**Re: Alectra Utilities Corporation
Application for Rates
OEB File Number EB-2017-0024**

Ontario Energy Board Staff Interrogatories
2017 Electricity Distribution Rate Application
Alectra Utilities Corporation (Alectra)
EB-2017-0024
September 18, 2017

Ref: Innovative Customer Engagement Report - Appendix 1.0 Enersource Telephone Survey Report, Residential 5-Year Capital Plan DSP, Pages 17-21

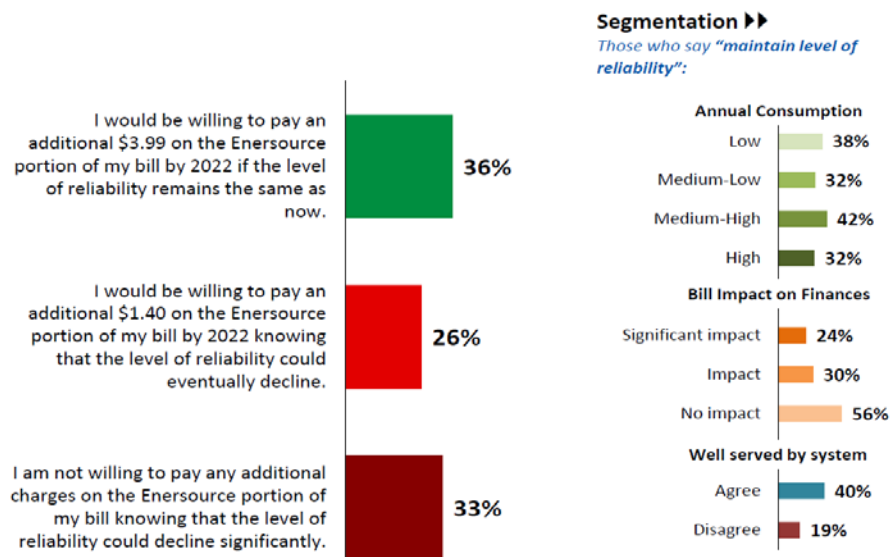
Pages 17-20 for the most part indicate some level of support for investment in system renewal, general plant, system service and modernizing the distribution system. This being said, the results from the DSP investment alternatives provided are reproduced below which show that a similar amount of customers are not willing to pay any additional charges when compared to those who are willing to pay an additional \$3.99 by 2022 (the rest are willing to pay about half).

- Please reconcile the two results.
- Has Alectra Utilities adjusted its planned spending within any area of capital spending for the forecast period taking into account the feedback provided by its customers? If so, what adjustments were made?

Figure 12 - Per-Unit Cost of Transformation Installation

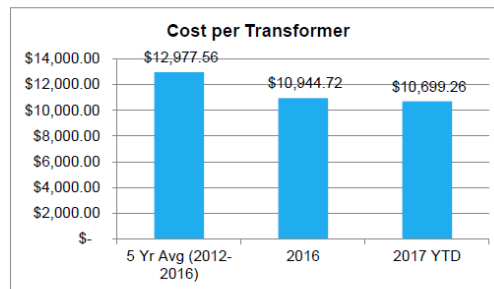
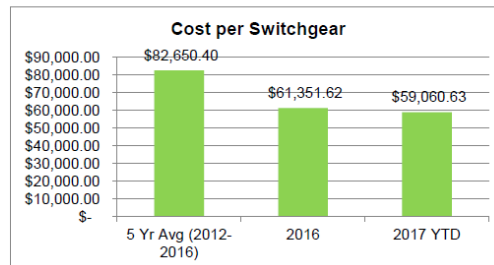
Please describe the cost elements comprising the achieved transformer and switchgear savings indicated in Figures 12 and 13 above.

Figure 62 - Main Feeder Cables Health Index Distribution

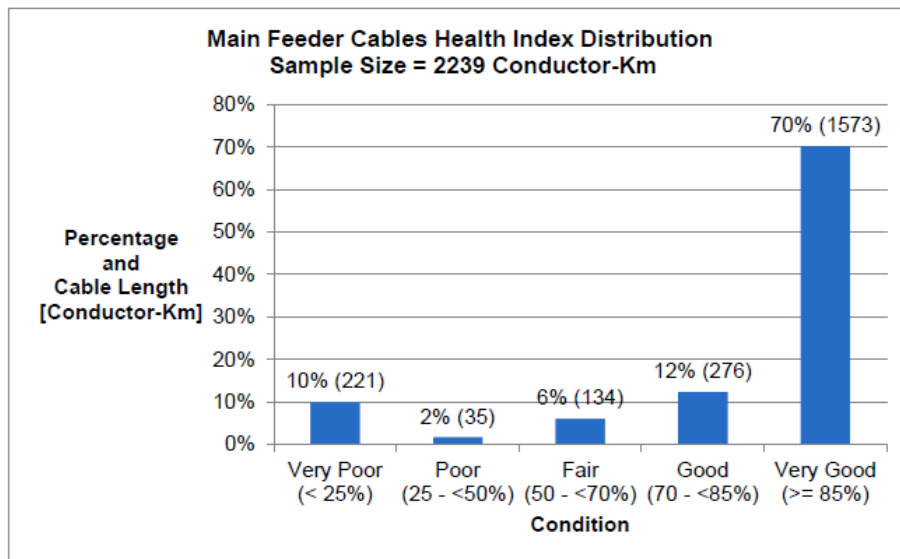
- Please discuss whether the Health Index Distribution in Figure 62 may be exaggerating the pool of Very Poor condition assets relative to the pool of Poor condition assets. What defining measure or parameter separates the two pools?
- Please provide an updated Figure 62 with Health Index Distribution based solely on performance.

Figure 94 - Enersource RZ Peak Demand Forecast - North 27.6kV Distribution System – Extreme Weather Scenario (1996-2035)

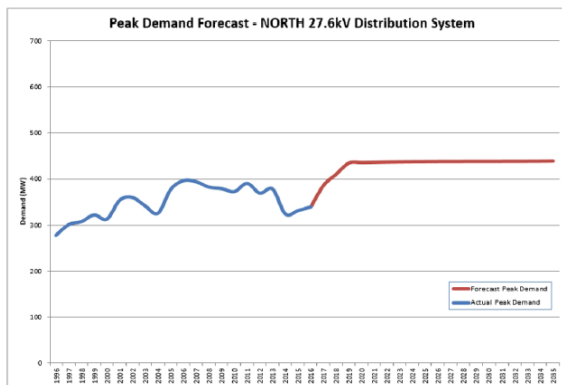
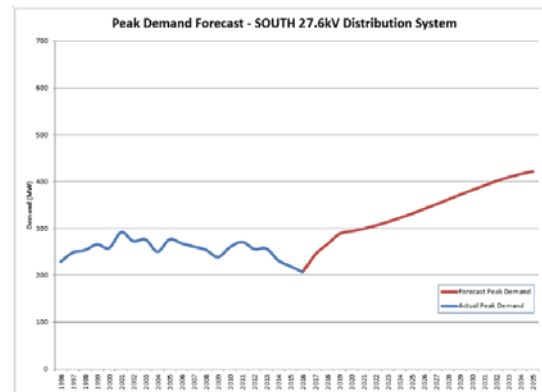
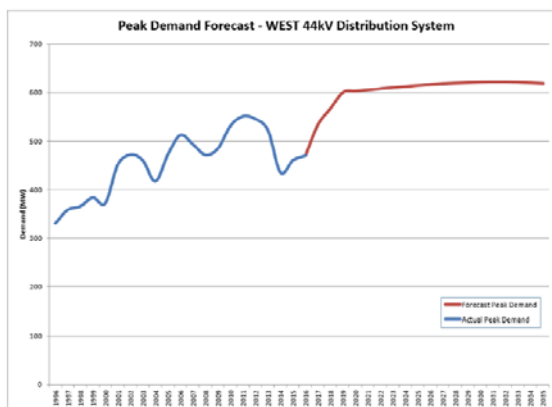
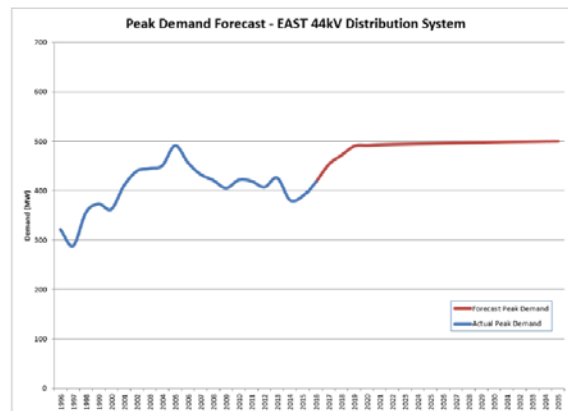
- a) The load growth forecast for years 2017, 2018 and 2019 shown in Figures 94, 95, 97 and 101 above seems high relative to actual load growth over the most recent 5 historical years. Assuming that the peak demand data for summer 2017 is now available, please provide updated Figures which include a comparison between Alectra's 2017 forecast loads and the actual year-to-date peak demand.
- b) The growth projections in Figure 101 show an increase in peak demand to approximately the same level as the historic peak. Please explain if the existing infrastructure is able to accommodate the forecast peaks? If no, why not?

Figure 110 - Trend of Cable Failures in Number of Failures

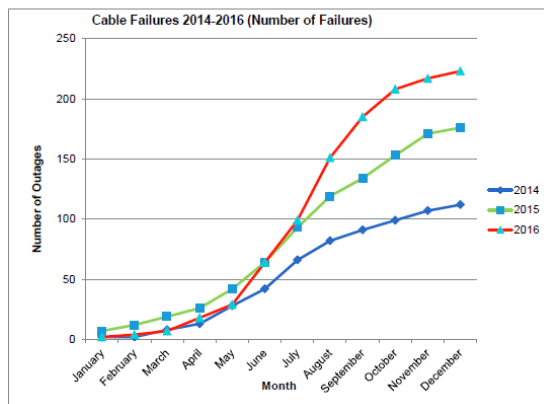
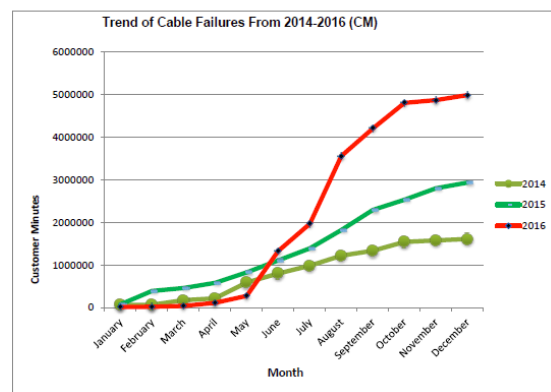
Please provide updated Figures 110 and 111 showing how 2017 cable failures are trending to date.
